PerkinElmer LAS, Inc., by this letter, notifies you that it wishes to inactivate the following device found in NR-536-D-110-B "Registry of Radioactive Sealed Sources and Devices"

CORRECTIONS

REGISTRY OF RADIOACTIVE SEALED SOURCES AND DEVICES
SAFETY EVALUATION OF DEVICE
(AMENDED IN ITS ENTIRETY)

NO: NR-536-D-110-B

ATTACHMENT 2

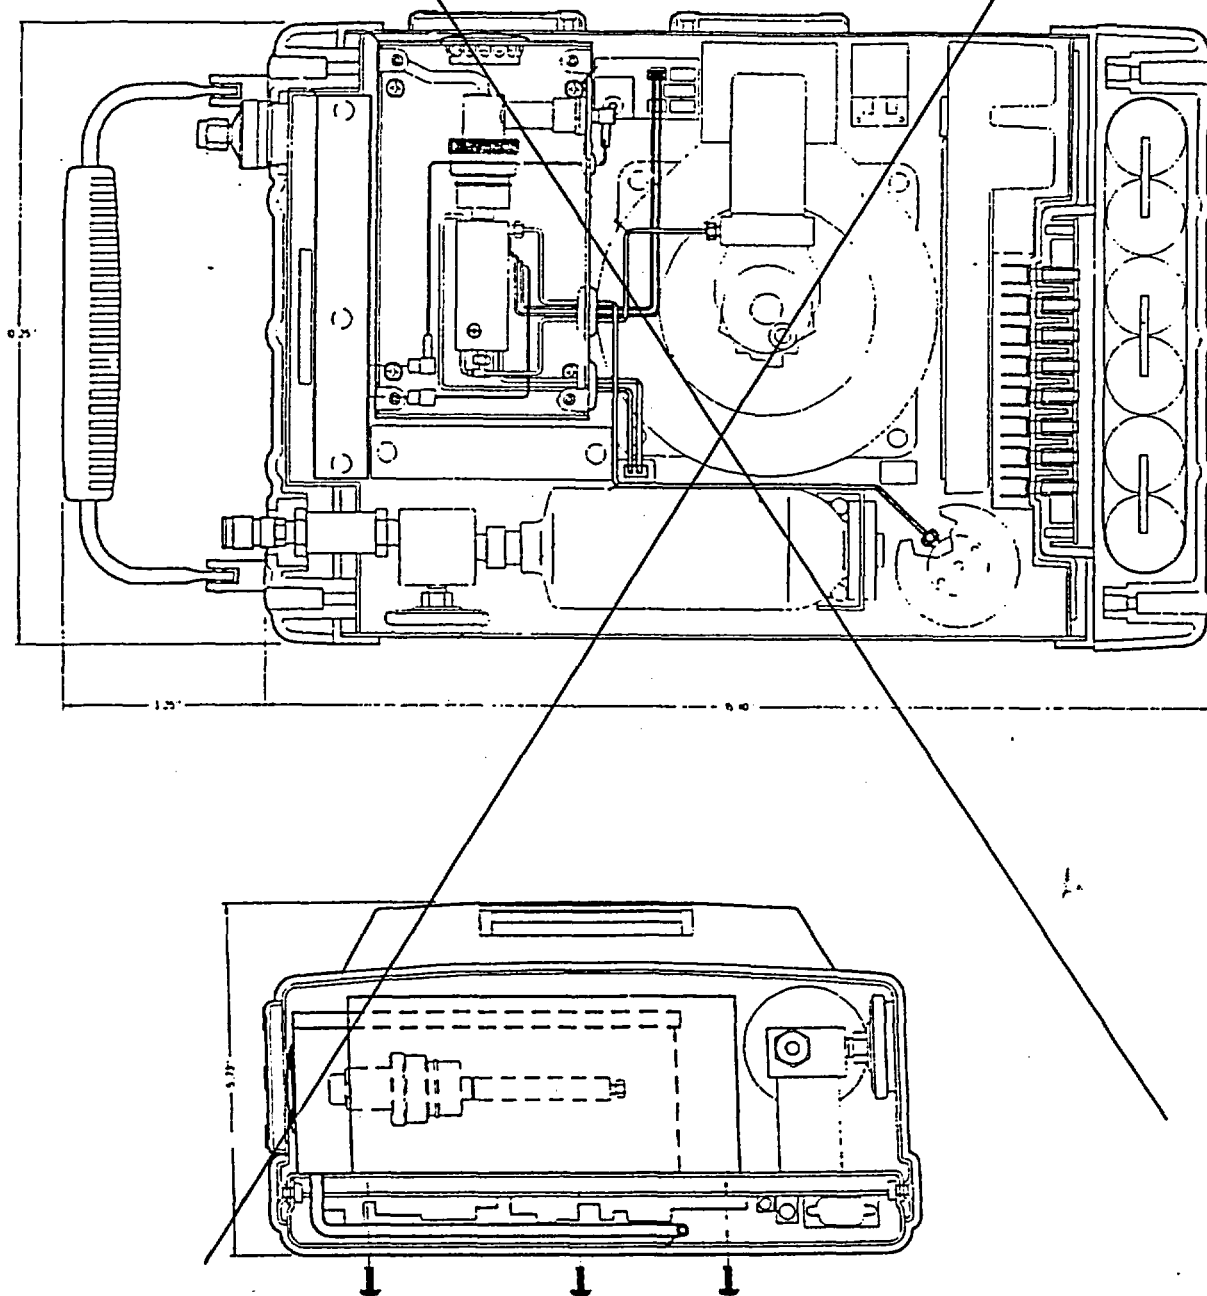
ATTACHMENT 2 & 3

Remove both attachments 2 & 3
